**Comment Response Matrix for
NRC Staff Clarification Questions on
DOE Responses to
Request for Additional Information on the
Draft Basis for Section 3116 Determination and
Associated Performance Assessment for the
H-Area Tank Farm at the Savannah River Site**

January 2014

Prepared by: Savannah River Remediation LLC
Waste Disposal Authority
Aiken, SC 29808

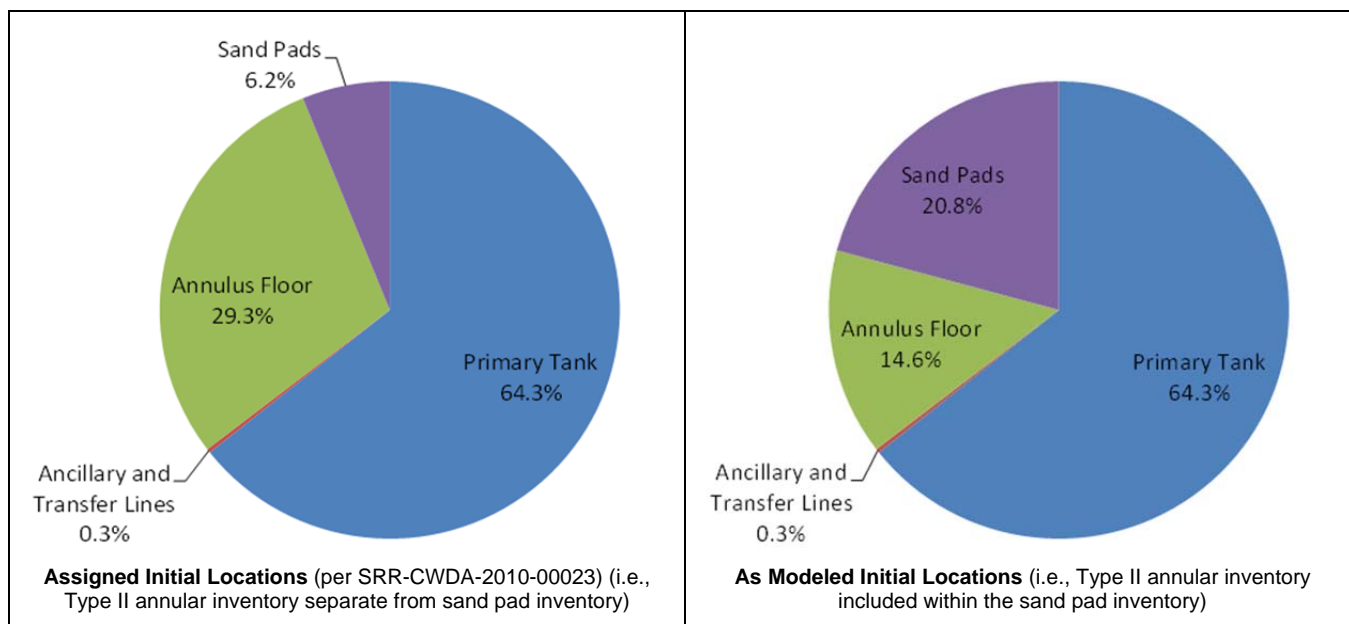
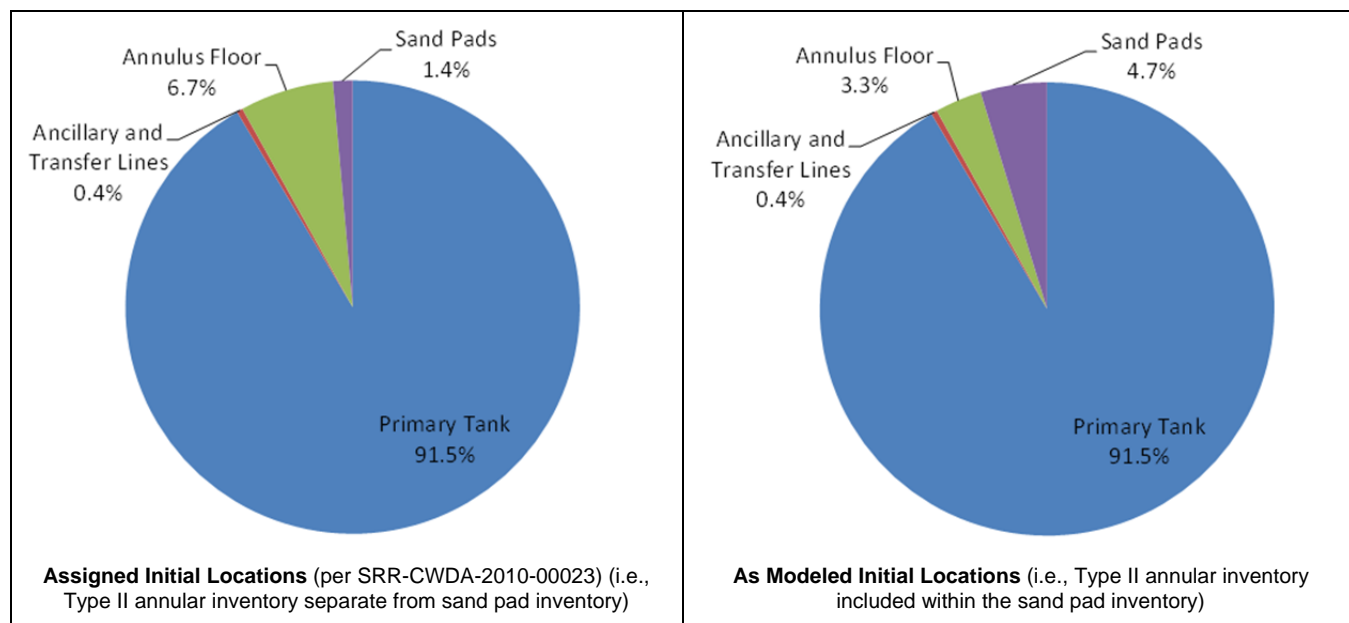
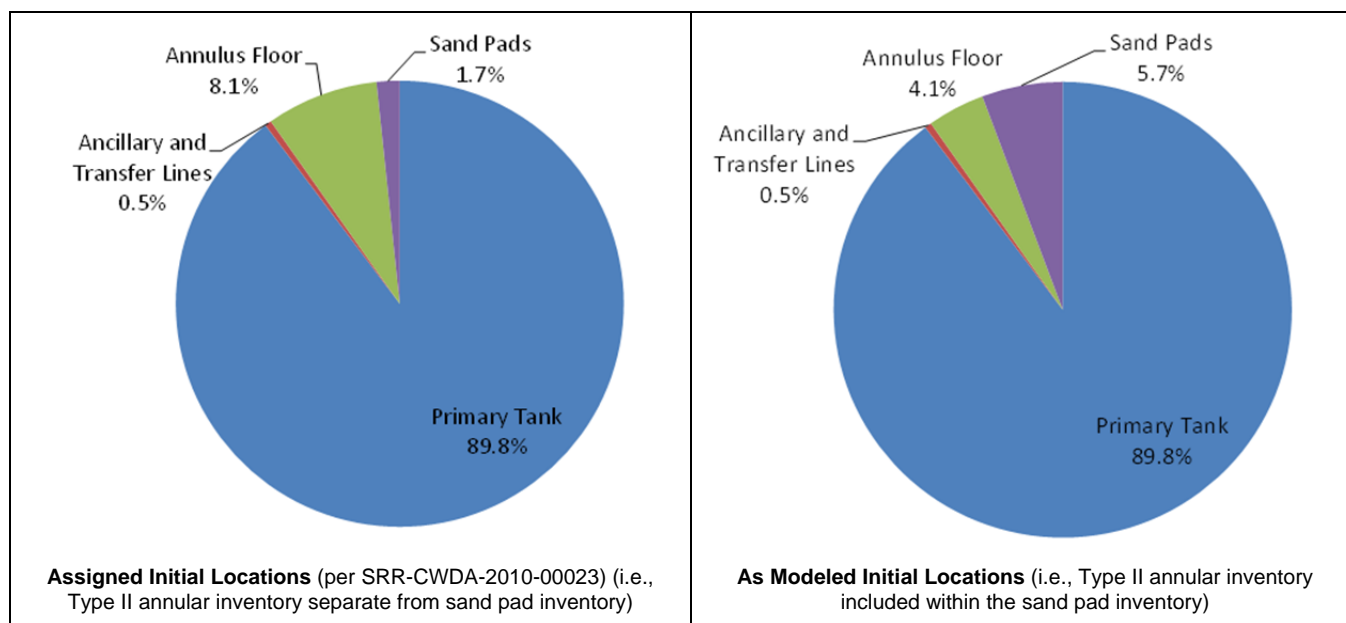
It is not clear to NRC staff whether DOE's response to RAI-NF-12, which relied on an analysis described in RAI-NF-8, adequately accounts for annular inventories. Please provide a table of the fractional release of Cs-137, Sr-90, Tc-99 out of the tanks and the mass storage in tank materials (e.g., sand pads, contaminated zone, basemat, annular grout, tank grout, tank wall concrete, preferential flow paths) over time for the analysis provided to respond to RAI-NF-12.

Figures CQ-2.1 through CQ-2.3 provide graphical representations of the initial inventory locations for Cs-137, Sr-90, and Tc-99, respectively, for the entire HTF inventory. These figures show the entire inventory for each material zone as summed over the entire tank farm. The figures provide a comparison of the "assigned" inventory¹ (i.e., with the sand pad and annular inventories separated in the Type II waste tanks) versus what was modeled for the HTF PA and for the RAI Response Document (i.e., annular inventories included within the primary sand pad zones for the Type II waste tanks). Note that the pie charts for the "as

modeled" inventories still include an annulus floor component which is associated with Type I waste tanks. These figures demonstrate that regardless of the assumed initial location of the Type II waste tank annular inventories (i.e., primary sand pad or grouted annulus material zone), the full inventories were considered and the bulk of the total inventory for each radionuclide is initially within the primary tank liner.

Figure CQ-2.4: Decay of Total Initial HTF Waste Inventory for Select Radionuclides

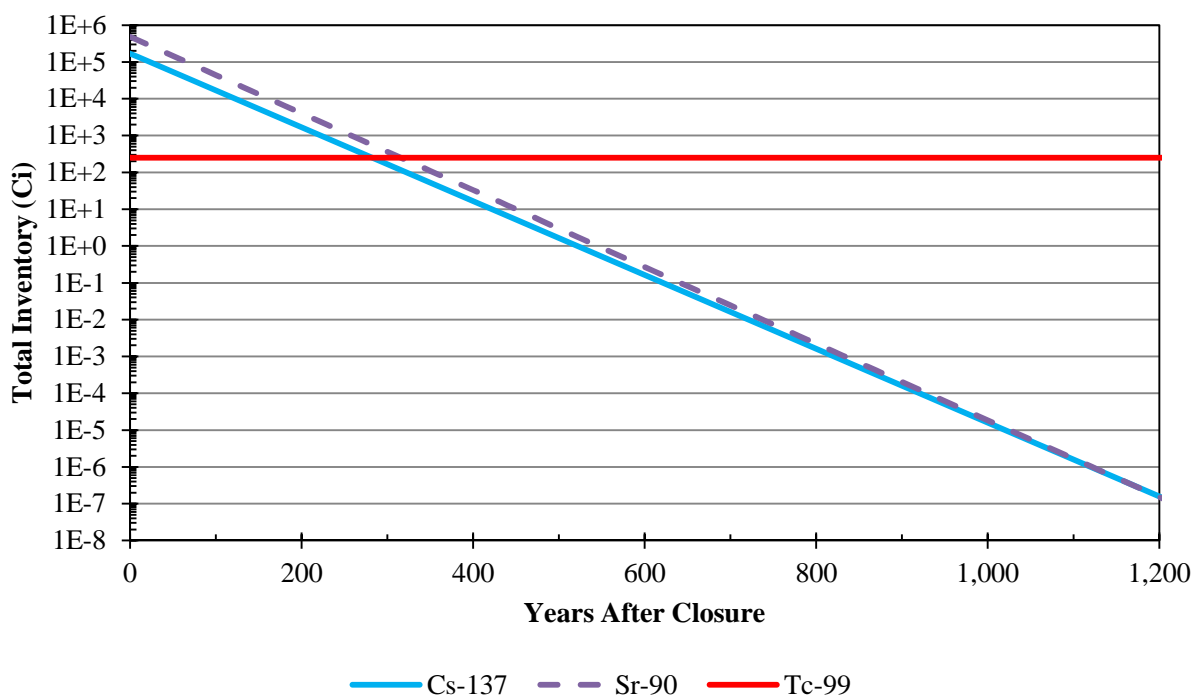
It is not clear to NRC staff how DOE came to the conclusion in RAI-NF-13 that there is no significant contribution from Cs-137 and Sr-90 located in the sand pads. NRC staff notes that the HTF PA has shown the potential for very high doses from Sr-90. In Section 5.6.4.3.2 of the HTF PA, DOE discussed two of the highest realizations from Case D that show Sr-90 doses for the MOP can be as high as 15,000 mrem/yr. NRC staff understands that these are the highest realizations from a case that DOE considers to be a low probability case; however, the parameters that appear to have most significantly influenced these MOP doses (e.g., inventory, K_d , dilution, water consumption) do not appear to account for the difference in results from the Flow Run 65, No Holdup case. Please provide a table of the fractional release of Cs-137, Sr-90, Tc-99 out of the tanks and the mass storage in tank materials (e.g., sand pads, contaminated zone, basemat, annular grout, tank grout, preferential flow paths) over time for the analysis provided to respond to RAI-NF-13.

Cesium-137 and Sr-90 have relatively short half-lives of approximately 30 years. Due to these short half-lives, within 1,000 years after closure the inventories for Cs-137 and Sr-90 decay to negligible amounts. Figure CQ-2.4 illustrates the decay of the total HTF PA inventories for Cs-137, Sr-90, and Tc-99. This figure combines the entire HTF PA inventories (from waste tank primary tanks, sand pads, and annuli, as well as ancillary equipment). For Tc-99, the differences in the assumed inventory locations only affects approximately 4% of the total available Tc-99 inventory. Therefore, the fractional release tables contained in the Microsoft Excel files being provided with this submittal (see Appendix B) only contain the “as modeled” data, and only show the first 2,000 years of data for Cs-137 and Sr-90. Tables CQ-2.1 through CQ-2.4 provide roadmaps of the information contained within the four Microsoft Excel files being provided in support of this response.

Figure CQ-7.1: Low Zone Outside H Area Southwest of HTF (Wells with Residuals > 6 foot)

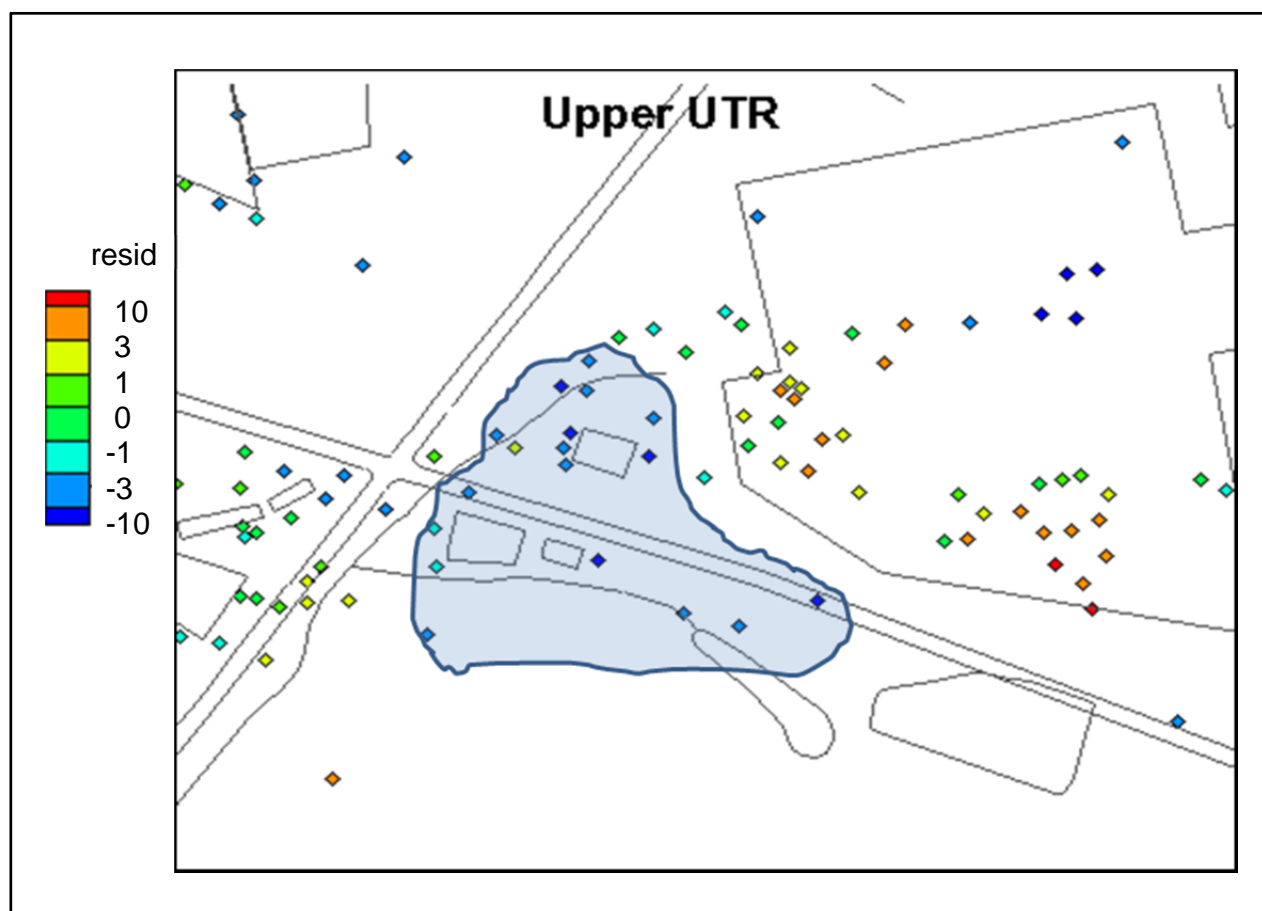
Please provide a legend for Figure RAI-FF-1.1.

The legend for Figure RAI-FF-1.1 from the RAI Response Document is the same as that used in Figure RAI-FF-1.2. Figure RAI-FF-1.1 is reproduced below with the addition of a legend for identification of well residuals values, measured in feet.

Figure CQ-9.1: UTRA-LZ Calibration Residuals (ft)

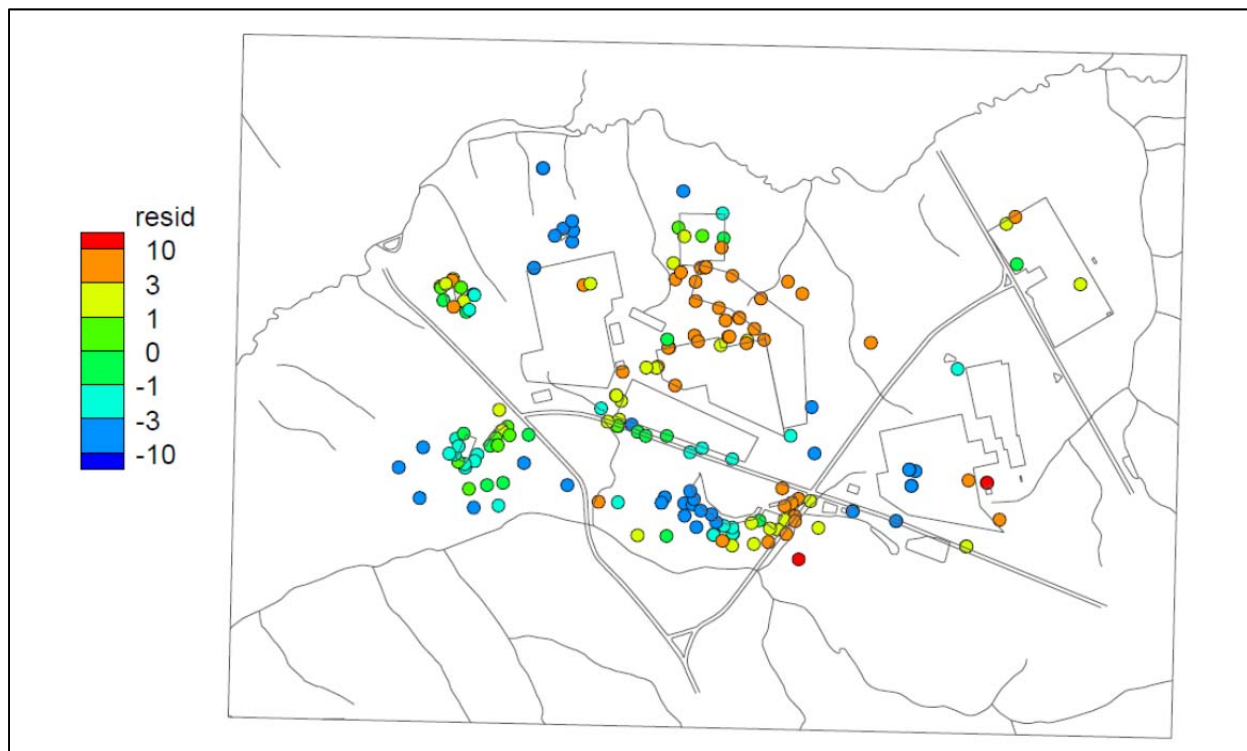
If no UTR-LZ calibration targets were evaluated in Table RAI-FF-2.4 for HTF, please comment on whether UTR-LZ calibration targets are available and on DOE's ability to evaluate HTF PORFLOW model calibration given the strong vertical gradient at HTF.

A few UTRA-LZ targets were available in the vicinity of HTF and were considered during calibration of the GSA/PORFLOW model. The calibration results for the UTRA-LZ targets are indicated in Figure 3-4(b) of *Groundwater Flow Model of the General Separations Area Using PORFLOW*, WSRC-TR-2004-00106, reproduced here as Figure CQ-9.1.

Figure CQ-11.1: 100-Meter Concentration Breakthrough Curves for 5-Year Pulse Release

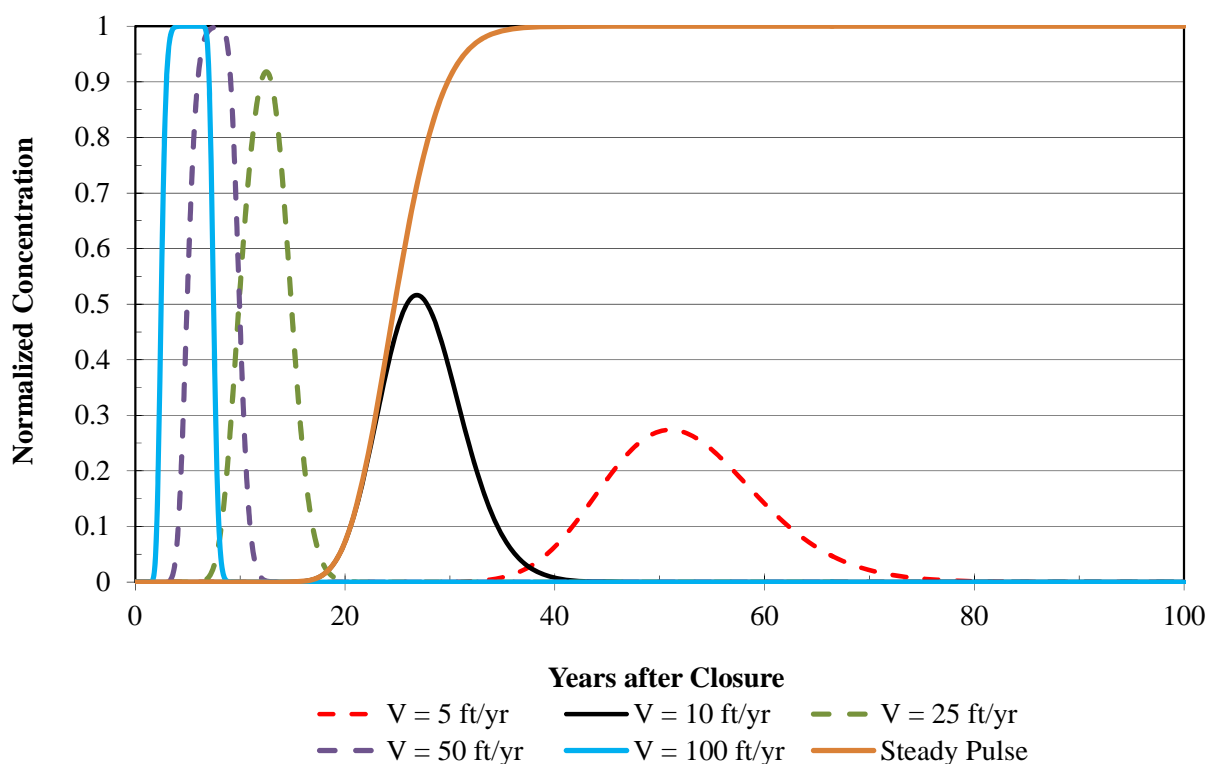
Please explain why Darcy velocity is not expected to impact longitudinal dispersion in the GoldSim model (see CC-FF-4 response on page 195).

The combined influence of the Darcy velocity and release profile will also influence the geometry of the plume. For a pulse release, the length of the pulse and velocity of the flow field together determine when and if the breakthrough curve reaches a quasi-steady state, and for how long the quasi-steady state condition will continue. For example, consider the results for the 5-year pulse simulation presented in Figure CC-FF-4.1 of the RAI Response Document. To show the combined influence of the flow rate and pulse duration, the 5-year pulse model was simulated using the updated velocities of 5 ft/yr, 25 ft/yr, 50 ft/yr, and 100 ft/yr. Note that the mass flux applied was also adjusted by factors of 0.5, 2.5, 5, and 10, respectively making the boundary concentrations, $C_o(t)$, the same so that dilution associated with the vadose zone/saturated zone water flux balance, was negated. The results are presented in Figure CQ-11.1. Notice how the changes in Darcy velocity influence the width and location of the breakthrough curve and how close to reaching a quasi-steady state condition each breakthrough curve comes. In the 100 ft/yr breakthrough curve a quasi-steady state condition is retained for approximately 3 years. As the velocity increases, the quasi-steady state condition will approach the pulse duration. These results can be anticipated by thinking of the pulse release in terms of superposition of two infinite source breakthrough curves as follows:

where t_{pulse} is the pulse duration and the time dependent boundary condition presented in Equation CQ-11.2 is a constant mass flux rate of infinite duration.
